## Grant Road Coalition, Central Segments \* November 26, 2019

### TOPIC: Linear Park – Health and Heritage Trail – Jefferson Park

Attached: Detail of comments on design of north side of Fremont to Santa Rita

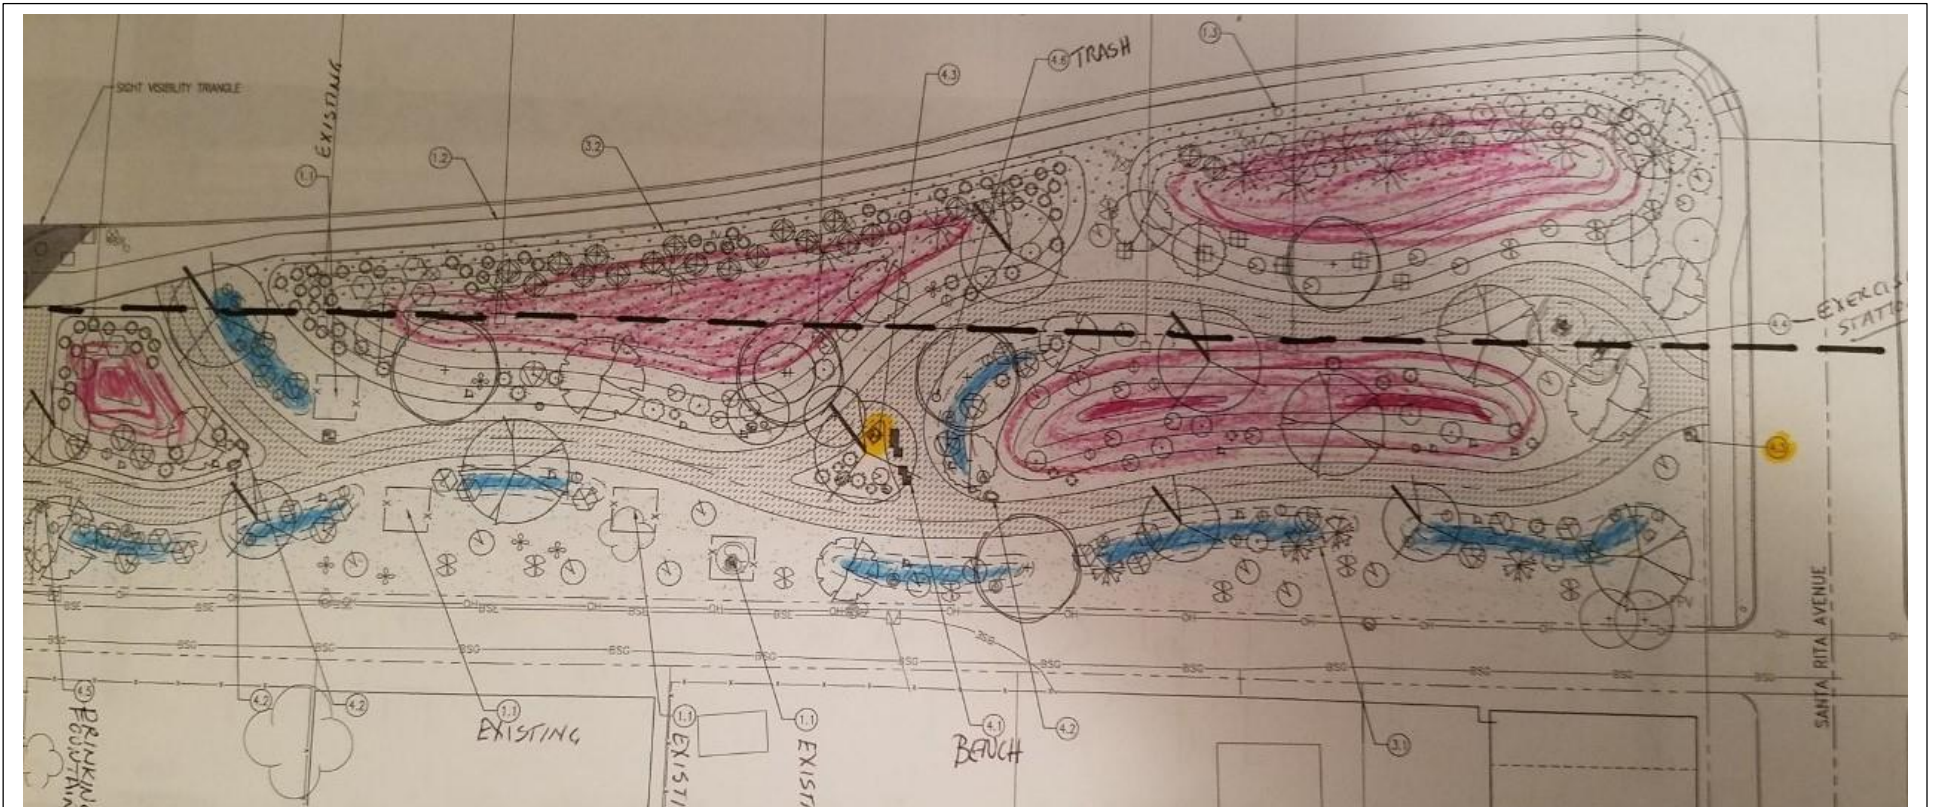
**BERMS:** The berm areas (red) and the basin areas (blue) - If this coloring is correct the following should be considered

- 1) In 10 years the park will lose 50% of the berms which are designed to mitigate the noise and visual distress of the encroaching road. If the design took that into consideration, the central berm, shown adjacent to the road, should be moved south. There is no guarantee that future TDOT construction would ameliorate the loss of that berm.
- 2) One of the water basins will extend into the cut area

**EXPENSIVE DG PATHWAY**

- 1) A second diverging DG pathway extends up into the projected "take area", unnecessarily. Note that the UA designs did not extend a pathway beyond the demarcation lines. Those plans were viewed and tentatively approved as concepts by the neighborhoods (see one UA proposal below)
- 2) About 30% of the expensive DG pathway will be demolished
- 3) Redesigning and eliminating the cost of the extra 30% of the pathway would help with the budget

**EXERCISE STATIONS WHICH WE HAVE NOW AGREED TO TRANSFORM INTO CLIMBING/SEATING SITES:**

- 1) The pictured exercise station are in the “take” area and are next to Santa Rita Avenue
- 2) Since we are considering them to be changed to seating/climbing possibly for youth, it is advisable that that entity be moved south and away from the streets

**VEGETATION:**

- 1) Several of the trees in the “take area” are of the larger 25 gallon varieties.
- 2) Moving the larger tree plantings south of the “take area” would be a better use of \$. The triangle “take area” could be landscaped with the less expensive but attractive plants—especially of the drought tolerant kind.
- 3) Irrigation system locations might take into consideration the eventual cut off of the watering system north of the line.
